# Access Compliance Report

## Public Rights-of-Way

### (Curb Ramps)

Intersection ID: 31549	Main Street: CROSS_ST	Cross Street: RED_SHED_LN	Location: SE
ADA ID: 28D35A6055DC	Ramp Type: PerpDiag	Initial Pass/Fail: Fail	Overall Compliance: No
Severity Score: 25			
Codes/Mitigation Info/Possible Solution		Field Measurements/Component Compliance

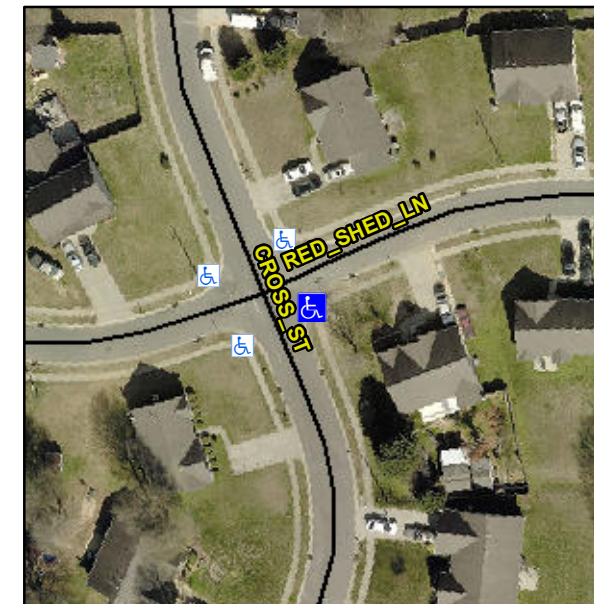
**Not Found, R304.2.2, R304.5.3**

Compliance	Description	Data	Compliance	Description	Data
N/A	Ramp Length (in)	48.0	No	Ramp Slope (%)	9.2
Yes	Ramp Width (in)	48.0	No	Ramp XSlope (%)	5.6
N/A	Flare Type LT	N/A	N/A	Flare Type RT	N/A
N/A	Flare Slope LT (%)	N/A	N/A	Flare Slope RT (%)	N/A
N/A	Flare Traversable LT?	N/A	N/A	Flare Traversable RT?	N/A
N/A	Landing Length (in)	N/A	N/A	DWS Provided?	N/A
N/A	Landing Width (in)	N/A	N/A	DWS Contrast?	N/A
N/A	Landing Slope (%)	N/A	N/A	DWS Length (in)	N/A
N/A	Landing X Slope (%)	N/A	N/A	DWS Full Width?	N/A
N/A	Landing Curb? (Y/N)	N/A	N/A	DWS Offset (in)	N/A
N/A	Shared Landing?	N/A			
N/A	Gutter Ponding?	N/A	N/A	Gutter Slope (%)	N/A
N/A	Gutter Lip Ht (in)	N/A	N/A	Gutter X Slope (%)	N/A
N/A	Painted X Walk1?	No	N/A	Painted X Walk2?	No
	X Walk 1 Direction	To N		X Walk 2 Direction	To W
N/A	X Walk 1 Width (in)	N/A	N/A	X Walk 2 Width (in)	N/A
	X Walk 1 Slope (%)	1.1		X Walk 2 Slope (%)	6.8
	X Walk 1 X Slope (%)	3.6		X Walk 2 X Slope (%)	0.7

**Remove & Replace Curb Ramp With Two New Directional Ramps or Equivalent.**
